P5024A-03-S

Safety Service Note

P5024A Keysight Streamline USB Vector Network Analyzer

“POTENTIAL BURN INJURY (HIGH TEMPERATURE) HAZARD”

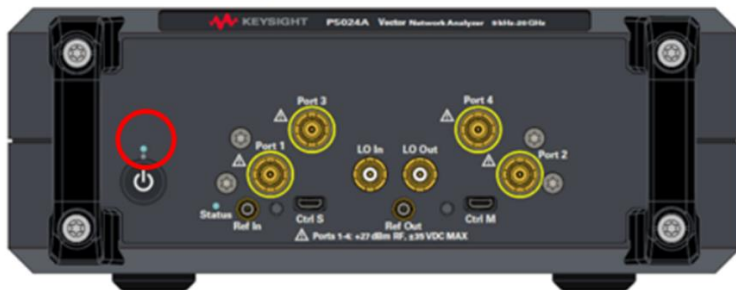
Symptom:

VNA fails to start with the following symptoms.

1. LED indicator (below circle) turns red.
2. cooling fan does not work
3. If user leaves the VNA with this LED indicator red without turning off power switch, it continues to overheat and becomes too hot.

Solution-1: Update VNA firmware by user

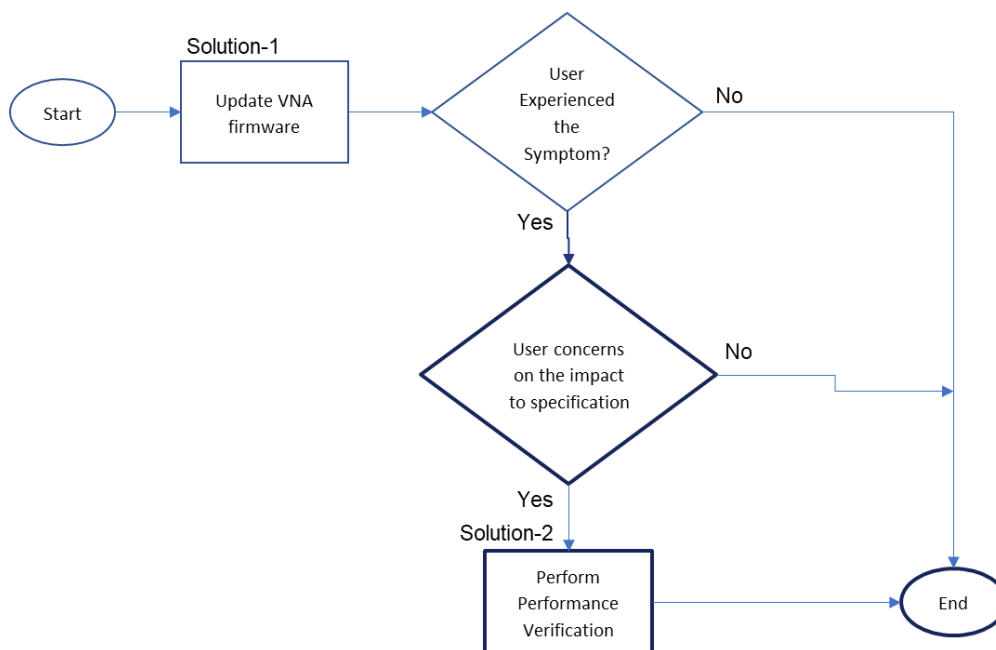
Action-1: Updating the firmware eliminates this potential risk of overheating.

1. **Install the latest VNA firmware Rev. A.15.40.13 or newer** on users' controller PC(s).
The latest firmware enhanced the thermal fan control mechanism.
2. Once the latest firmware is installed, proceed with the restart of both **controller PC** and **VNA**.
3. Launch the VNA firmware. Ensure VNA powers up and launches into firmware correctly after firmware update is done.
